NEDO-31960-A

Licensing Topical Report

BWR Owners' Group Long-Term Stability Solutions Licensing Methodology

Figure A.1. Comparison between corewide decay ratios calculated by LAPUR and FABLE.

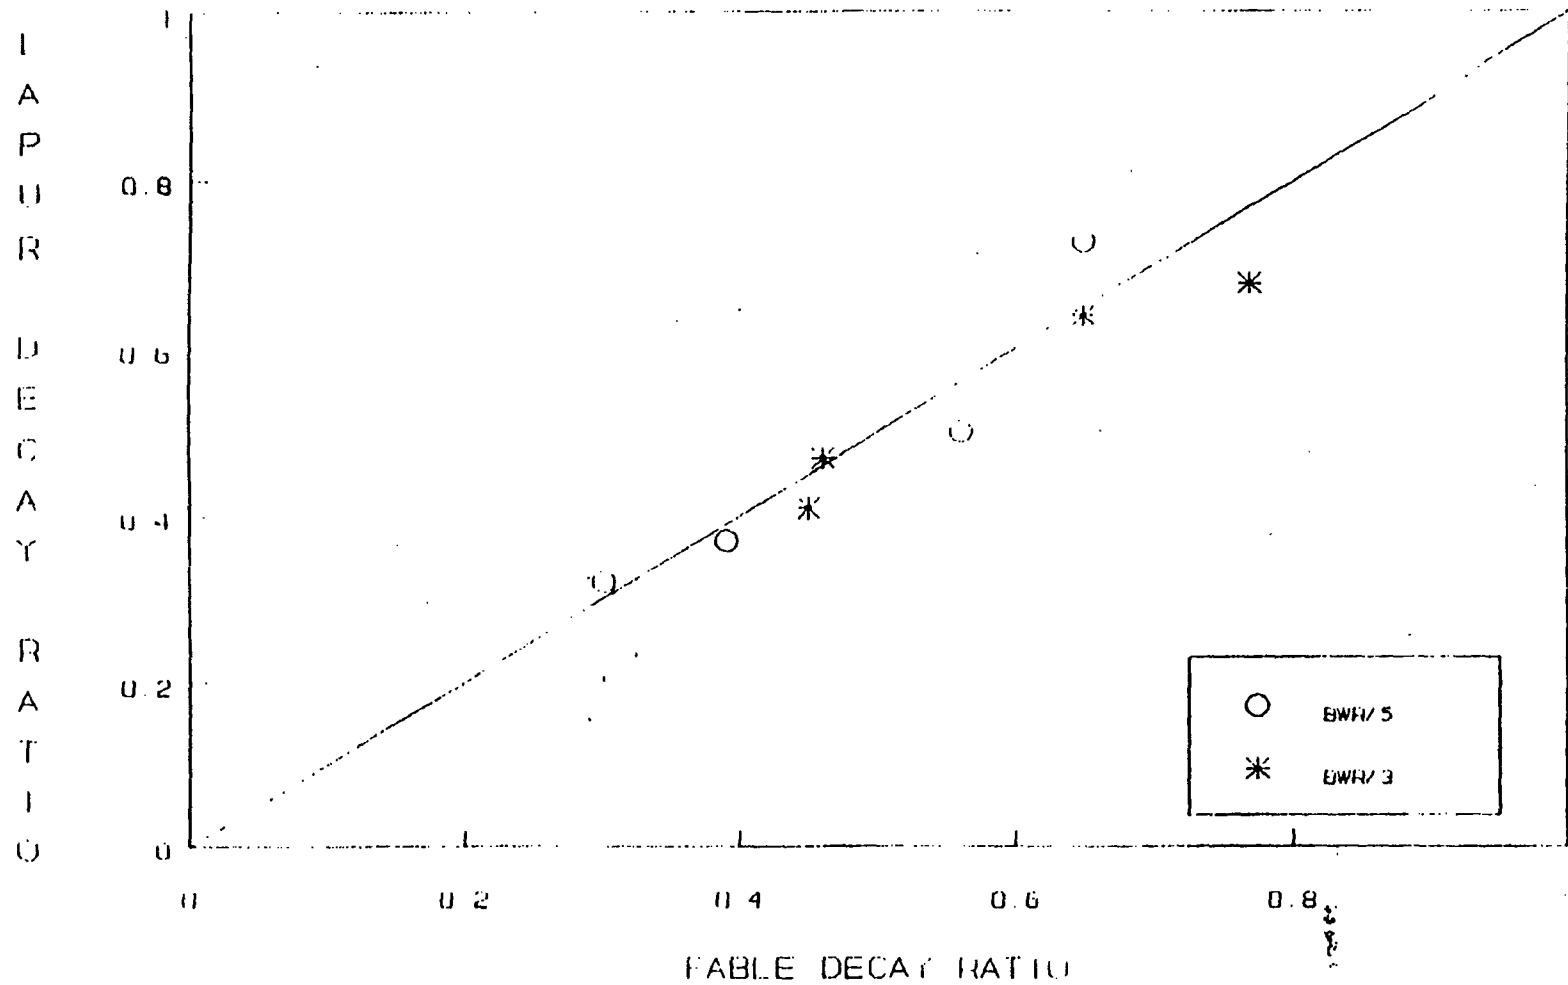
A series of audit calculations were performed with the LAPUR code to verify the results presented by the BWROG that were based on FABLE/BYPSS calculations. All relevant input data used in the FABLE/BYPSS was made available for this review, and we set up LAPUR input decks that were representative of the conditions modeled by FABLE. The main result of these calculations is presented in Table A.1 and Figs A.1 and A.2. We observe that the maximum difference between LAPUR- and FABLE-calculated decay ratios is 0.09. This can be considered as excellent agreement and representative of the differences in modeling of both codes.

Figure A.5. Comparison between equilibrium-cycle exclusion region and the exclusion region for the specific operating conditions of a BWR/5 instability event.

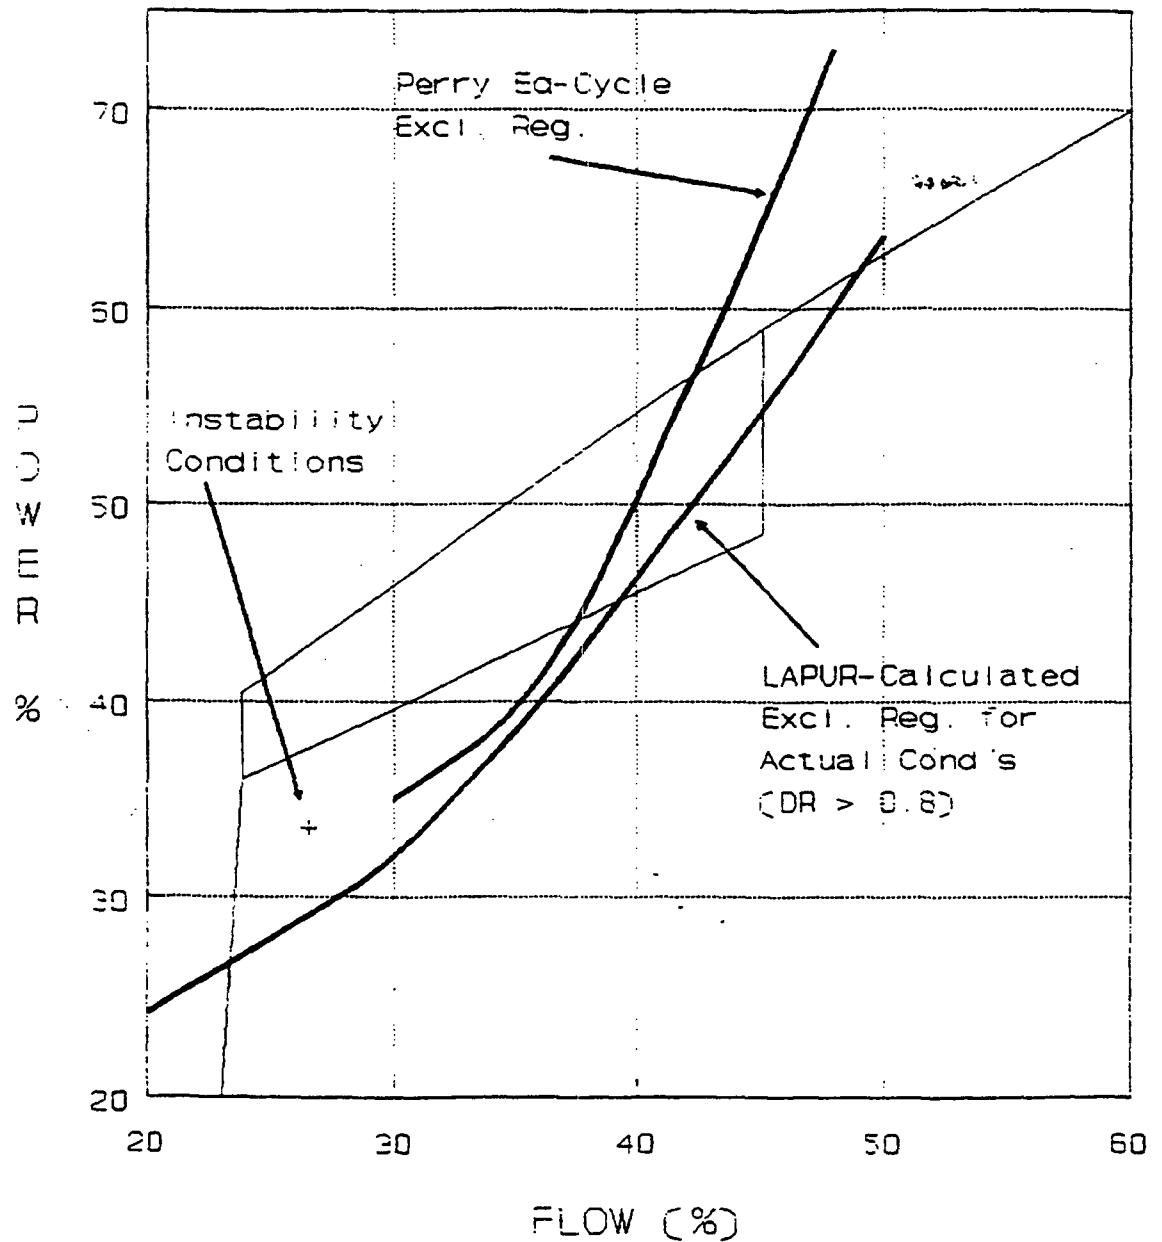
Figure A.5 shows a comparison of the equilibrium-cycle exclusion region for the Perry reactor (a BWR/6) and the exclusion region that results if the actual axial and power shapes from the recent BWR/5 event are used. As it can be observed, the standard BWR/6 exclusion region from NEDO-31960 is not as conservative as the actual region. Therefore, we have recommended that the BWROG must establish a criteria to limit the actual radial and axial peaking factors during startup operations to those values considered for the analyses of the exclusion region. This criteria must be based on parameters or information readily available to the operator in the control room.
